JOB TITLE:
PROPOSED BLUE SKILLS TRAINING FOR EMPLOYMENT CENTRE (BSTEC) FOR THE KISUMU NATIONAL POLYTECHNIC ON KISUMU MUNICIPALITY / BLOCK 9 / 101

DRAWING TITLE:
SITE PLAN

P-150	DRG. NO: 01	REVISION:	DRAWN BY: J.O.O.
	SCALE: 1:300	DATE: MAR 2026	CHECKED BY: O.M.

VISITOR'S CENTRE AND AQUA CENTRE PLAN
Scale 1:100

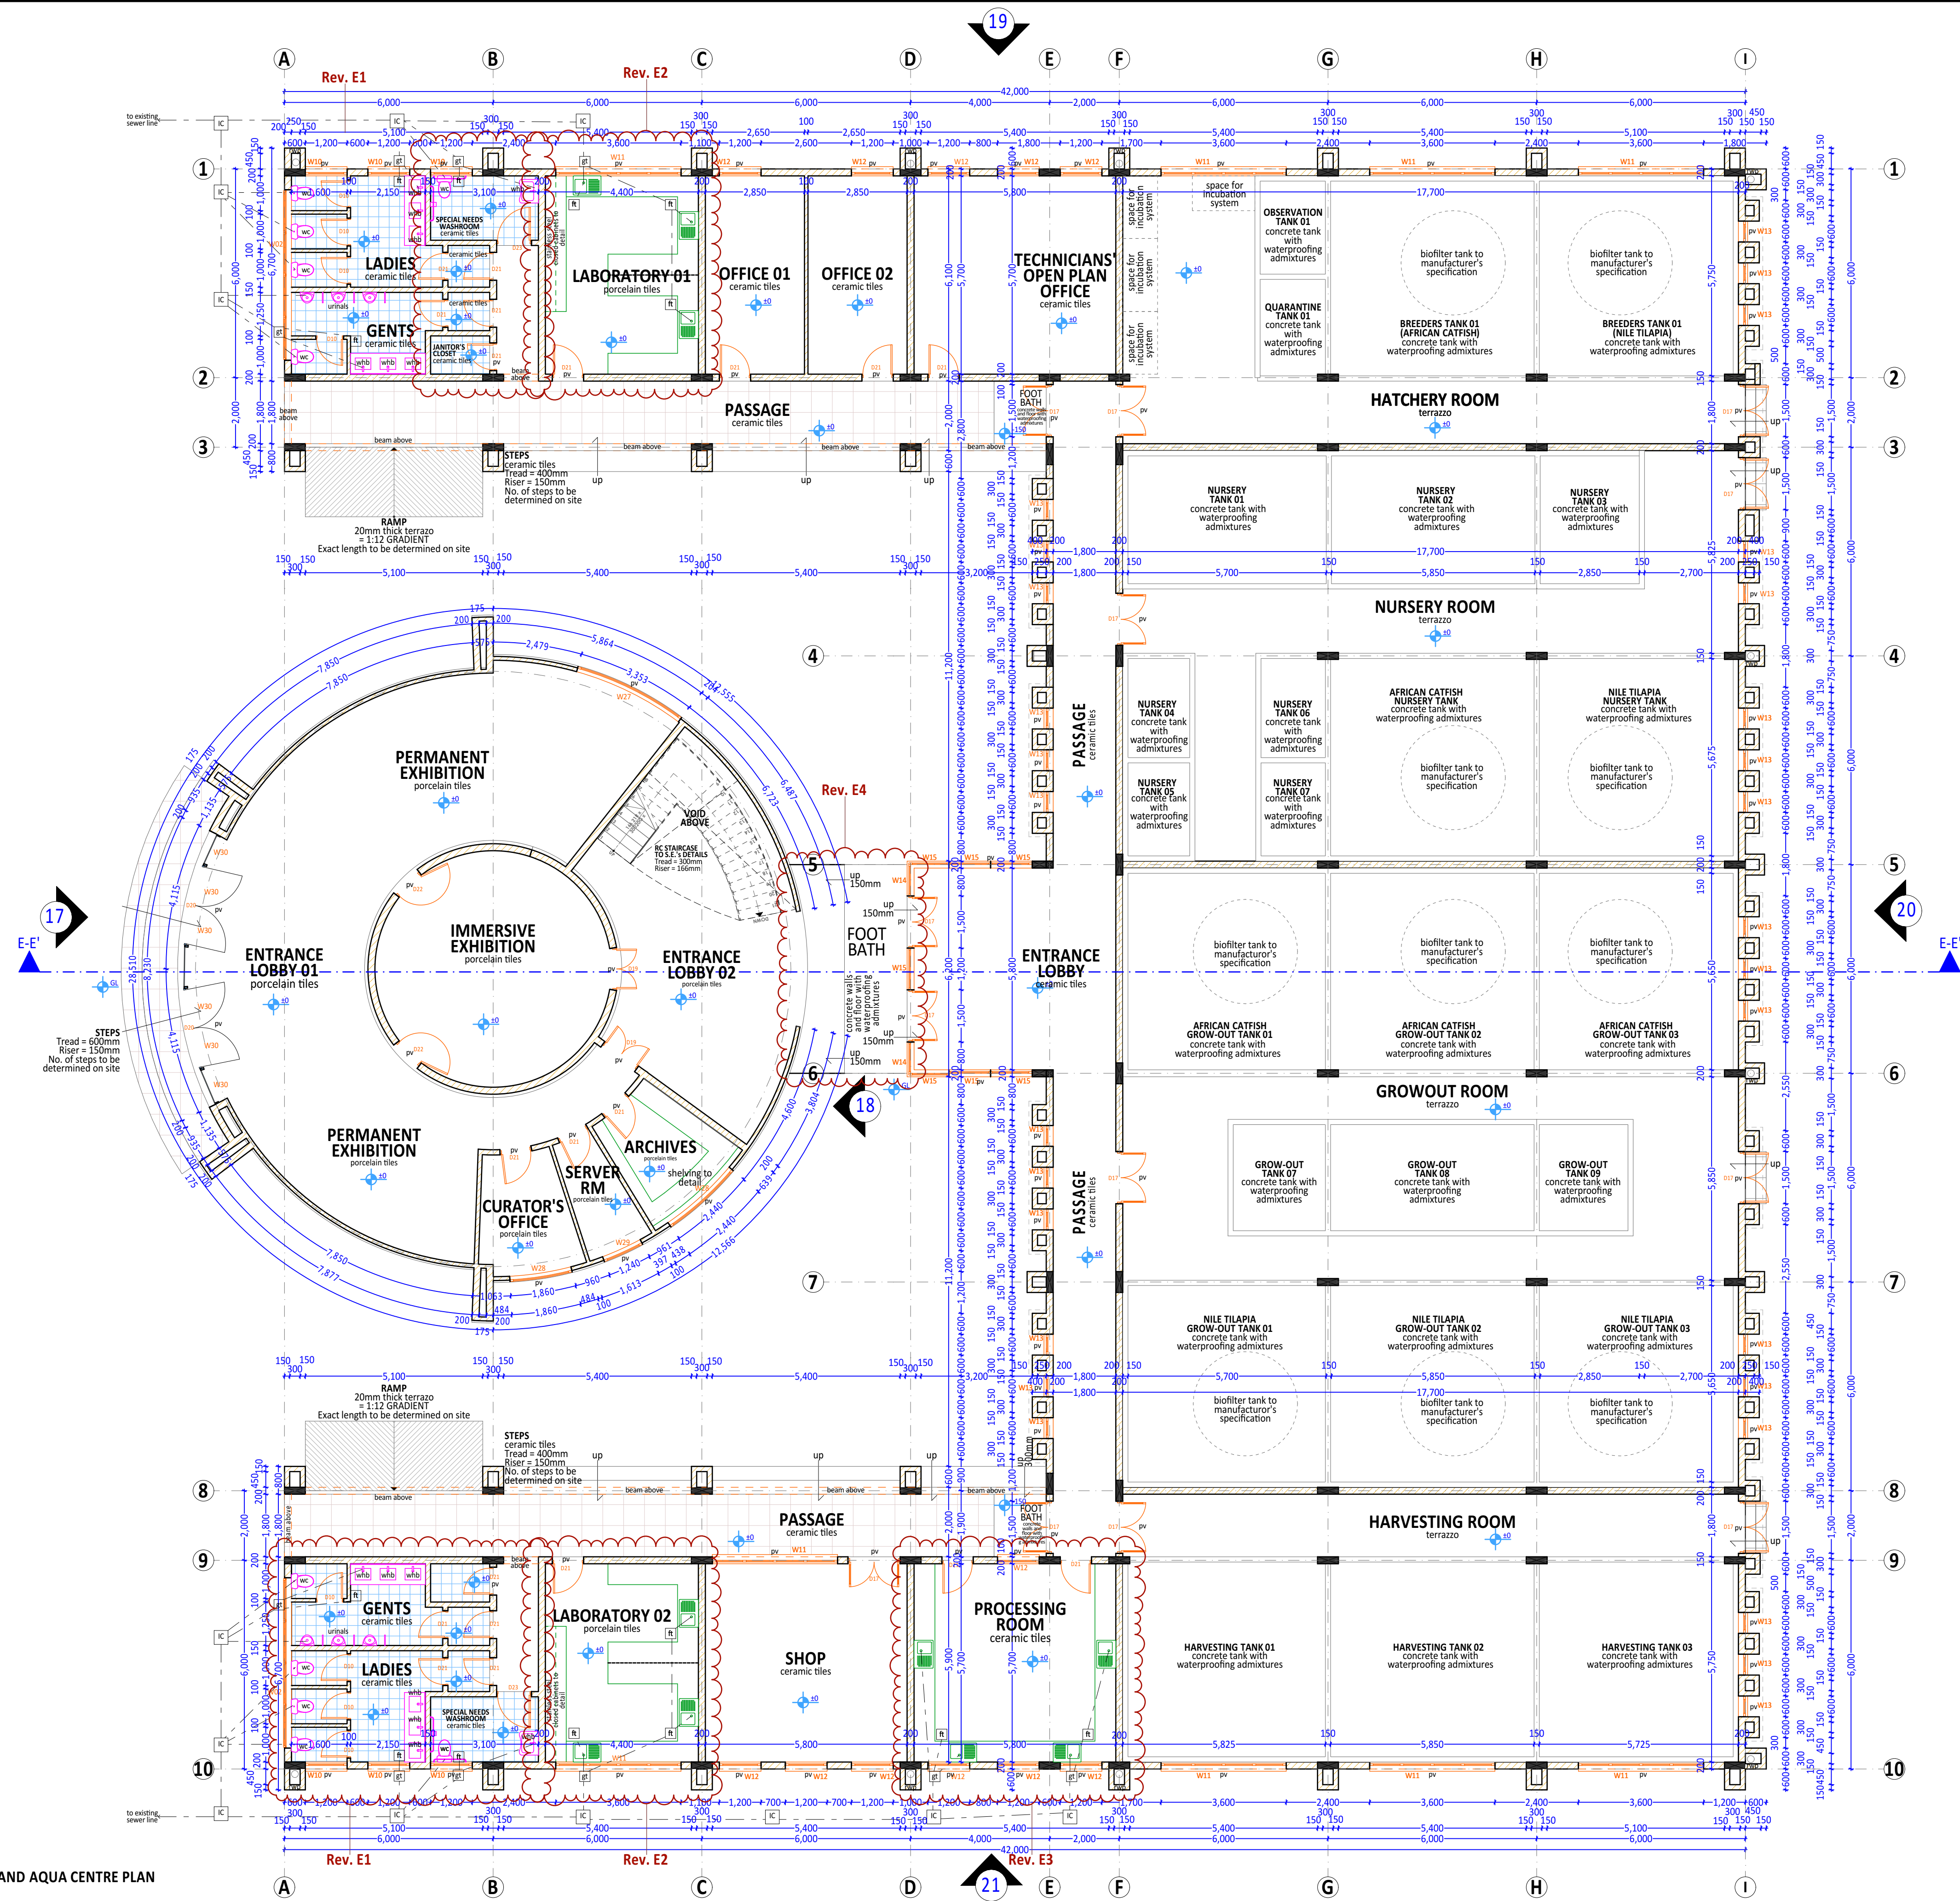
No.	Date	Revision/Issue
Rev. E1	15/06/26	Ladies, Gents, Special Needs washrooms have separate vestibules. Janitor's closet introduced.
Rev. E2	15/06/26	Joinery, plumbing and drainage introduced in the Laboratories 01 and 02.
Rev. E3	15/06/26	Joinery, plumbing and drainage introduced in the Processing Room
Rev. E4	15/06/26	300mm steps rise omitted. 50mm step for footbath maintained.

DRAWING TITLE:
**TEACHING BUILDING -
ROOF PLAN, GROUND FLOOR PLAN, ELEVATION 30,
ELEVATION 31**

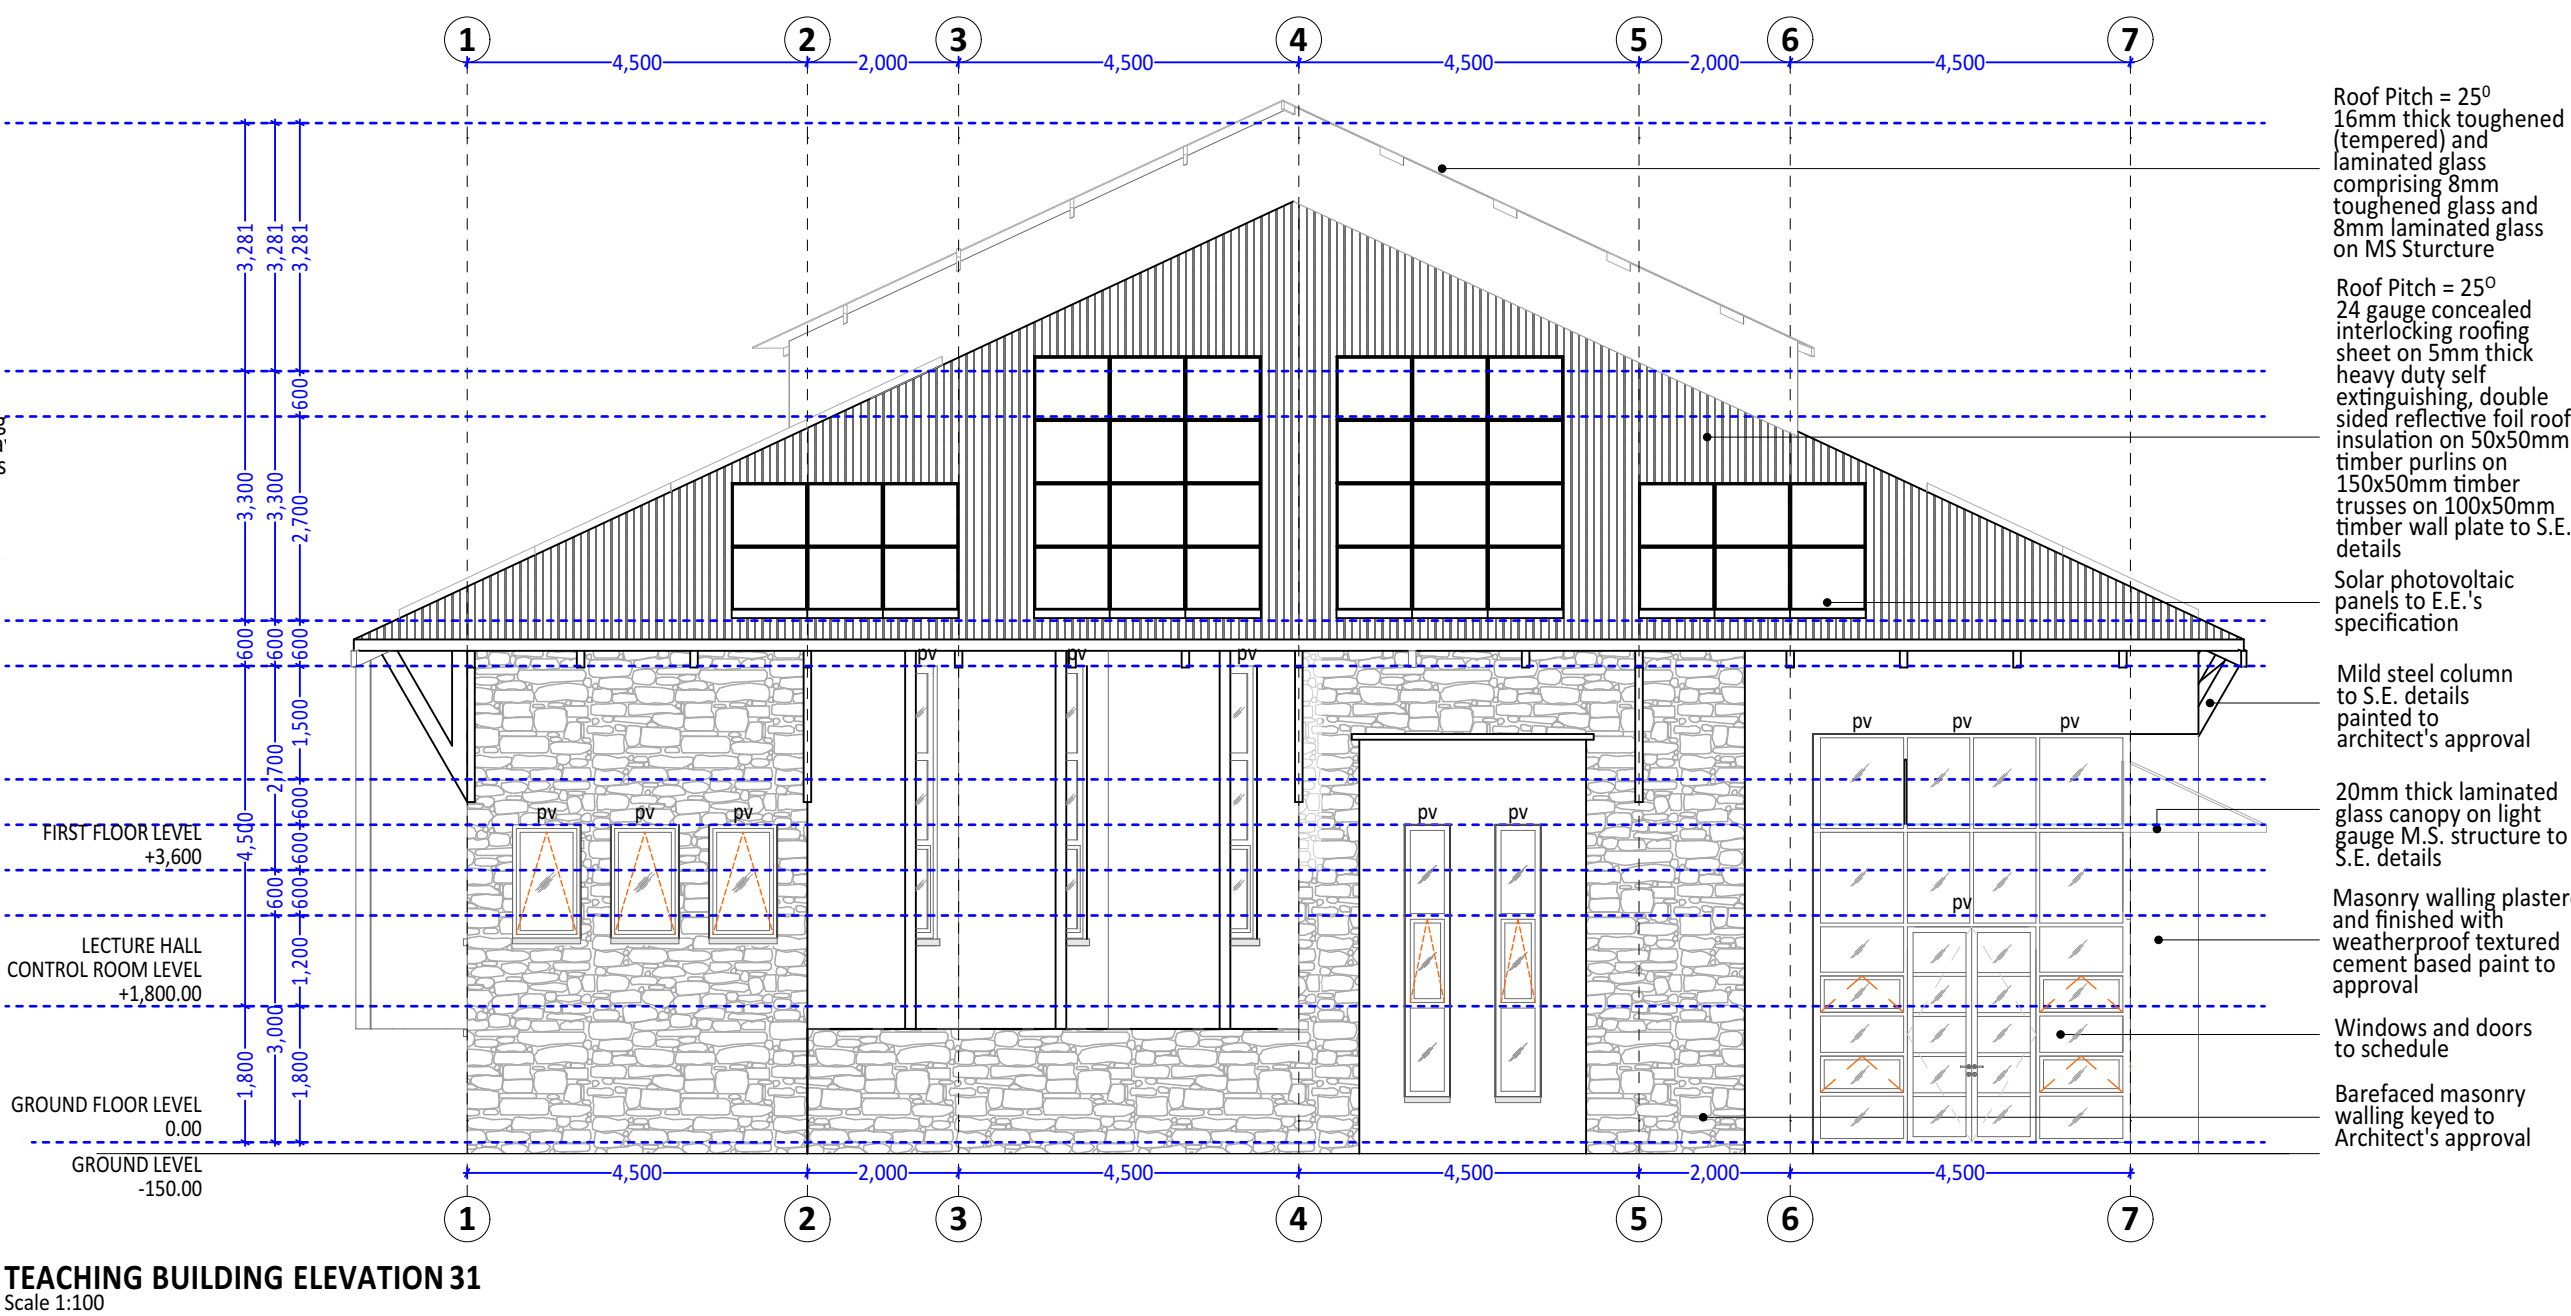
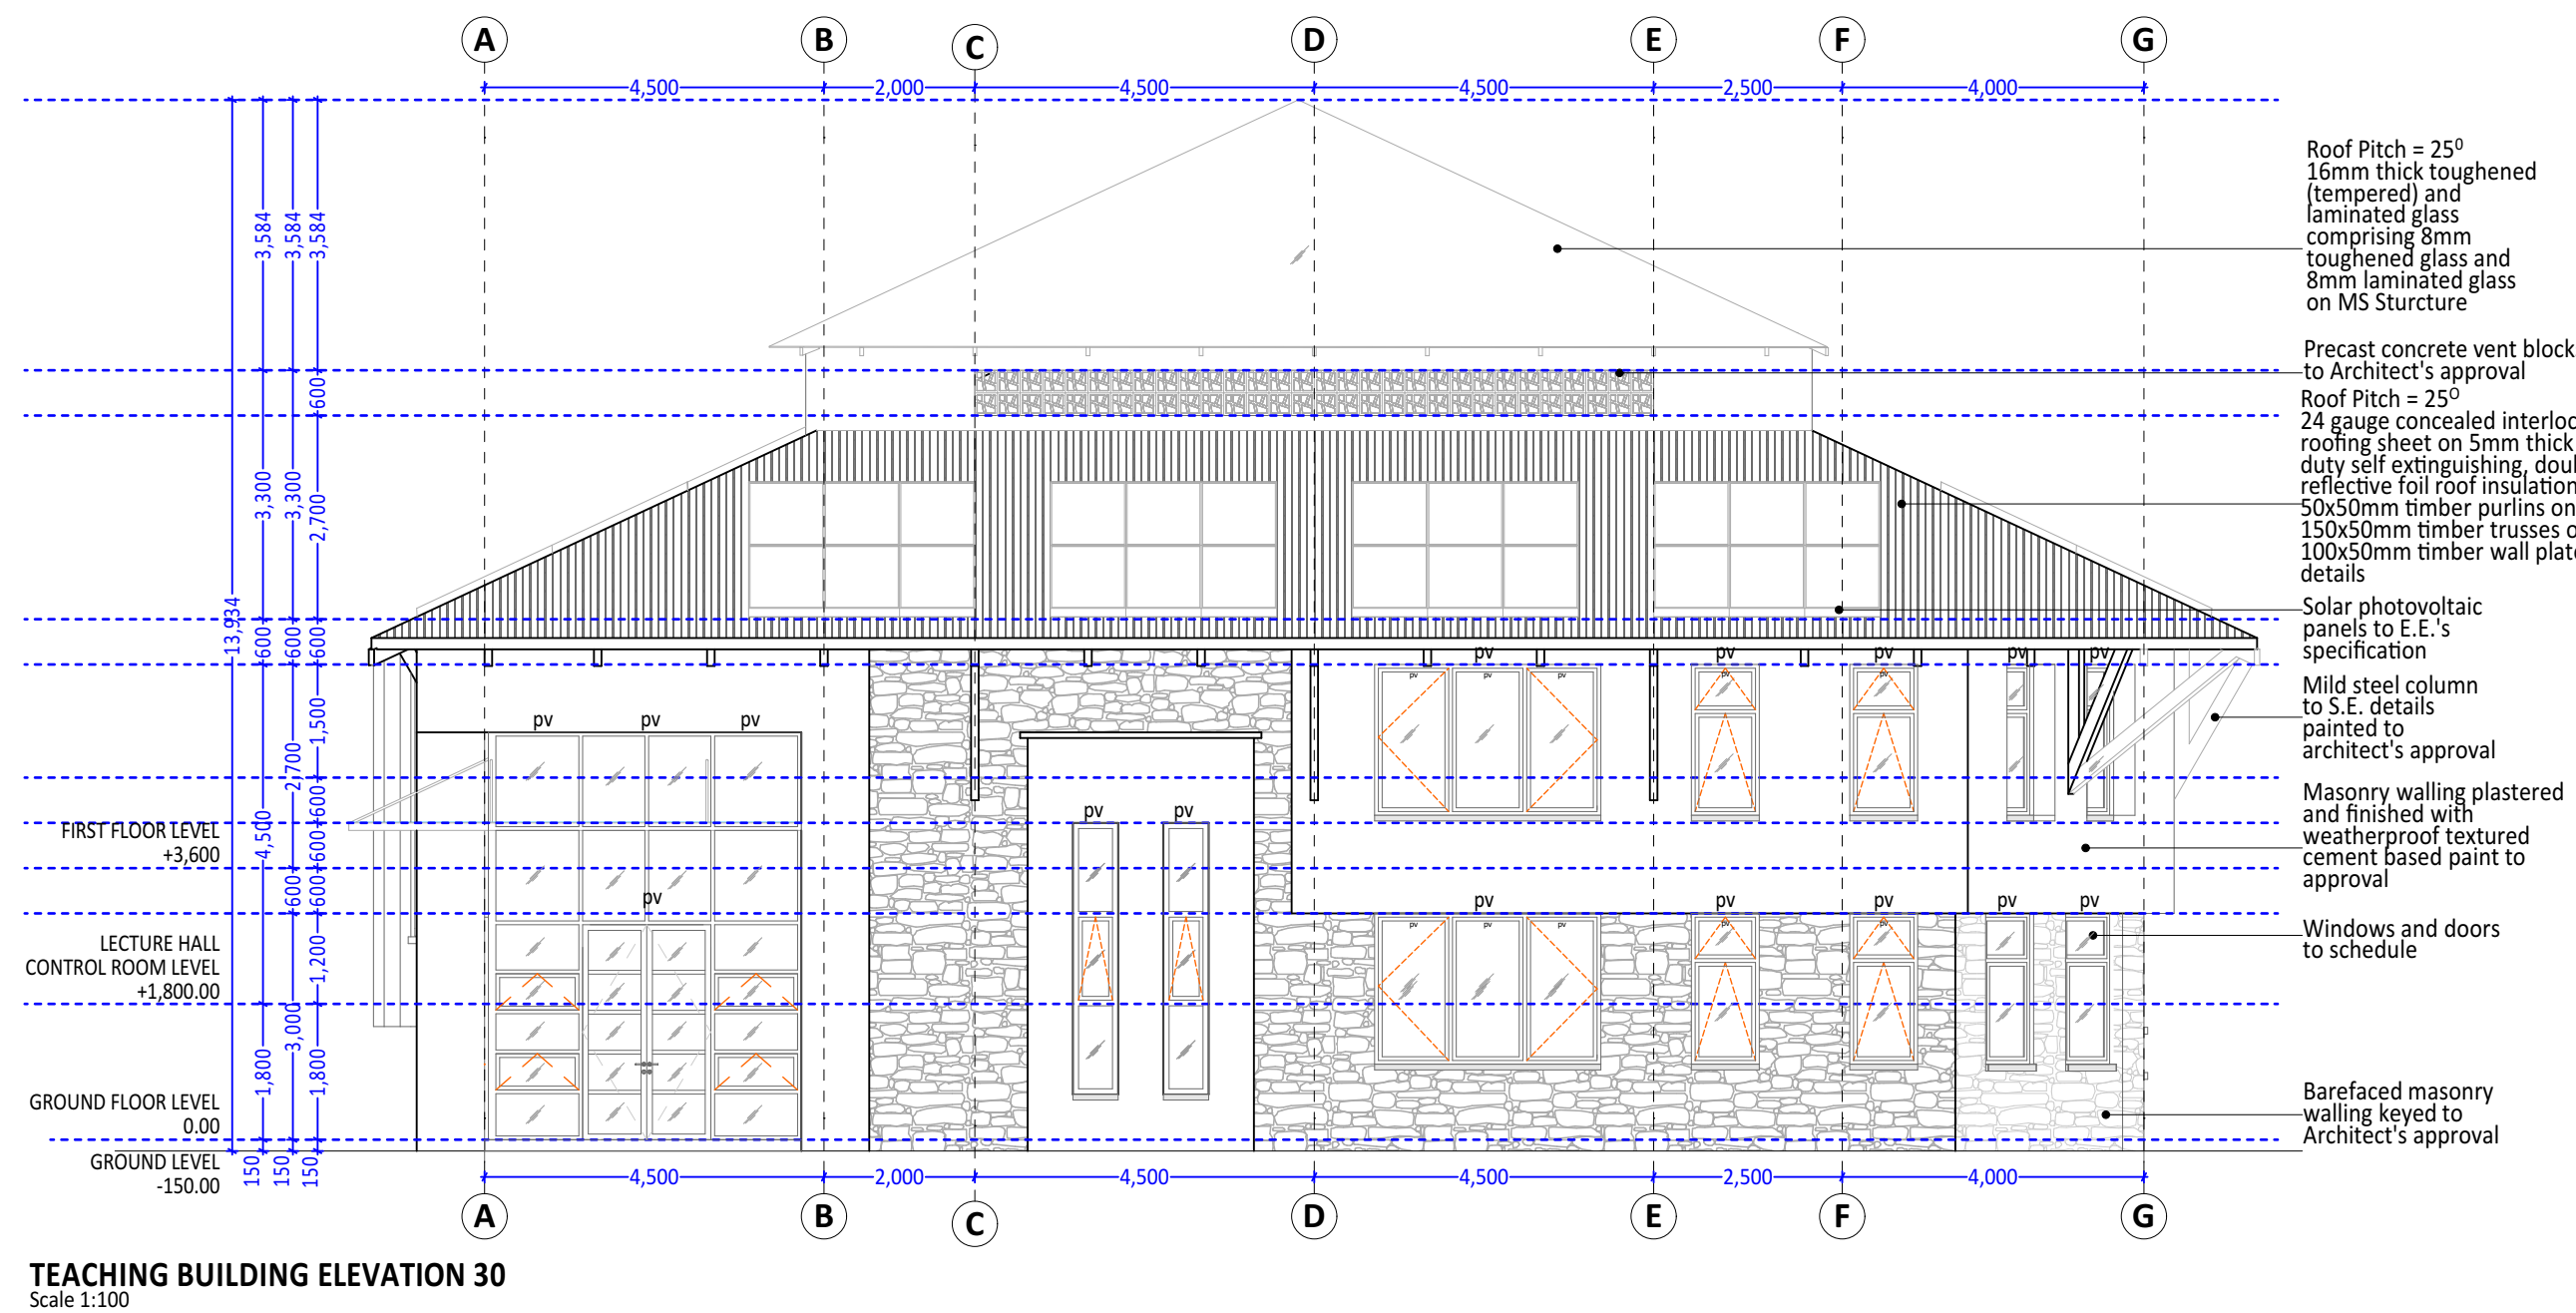
No.	Date	Revision/Issue
Rev. H1	15/06/26	Classrooms have been revised to be a Computer Laboratory of 96m².
